PCN #: 2568

PCN Title: Qualified Additional Assembly & Test Sites, Bill of Material, and updated Device Data Sheets for Package Outline Dimension Change

PCN-2568 REV 1

Table A

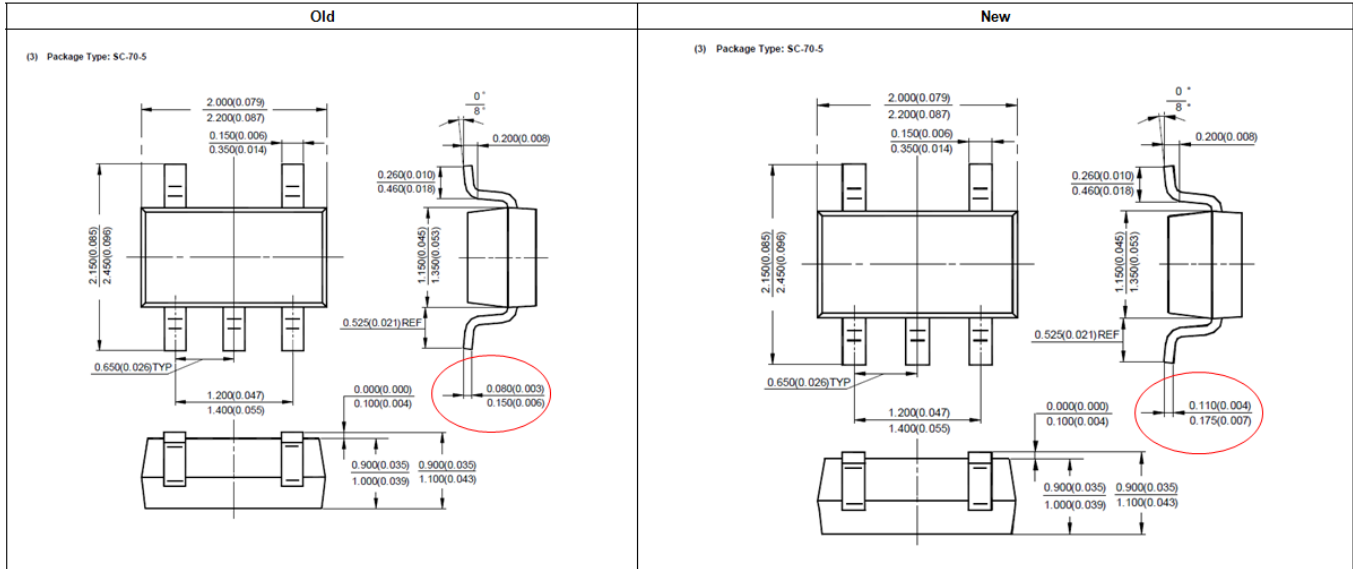
Lead Thickness

Old Lead Frame		New Lead Frame		Units
Min	Max	Min	Max	
.080θ	.150	.110	.175	mm

Table B

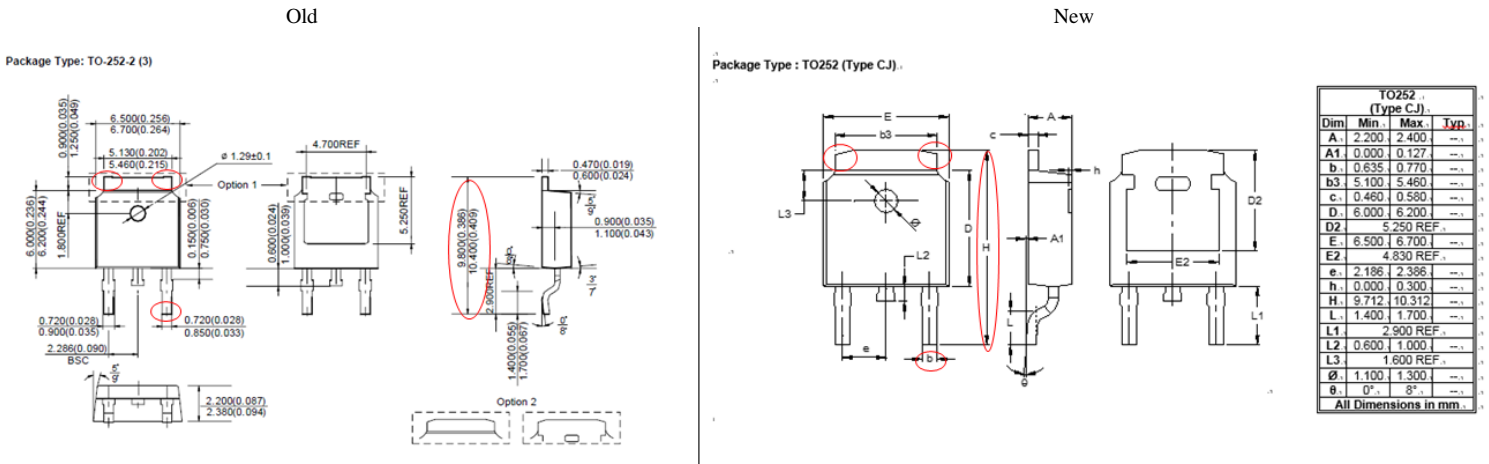
Total Height

Old		New		Units
Min	Max	Min	Max	
9.800	10.400	9.712	10.312	mm

Lead Width

Old		New		Units
Min	Max	Min	Max	
.720	.850	.635	.770	mm
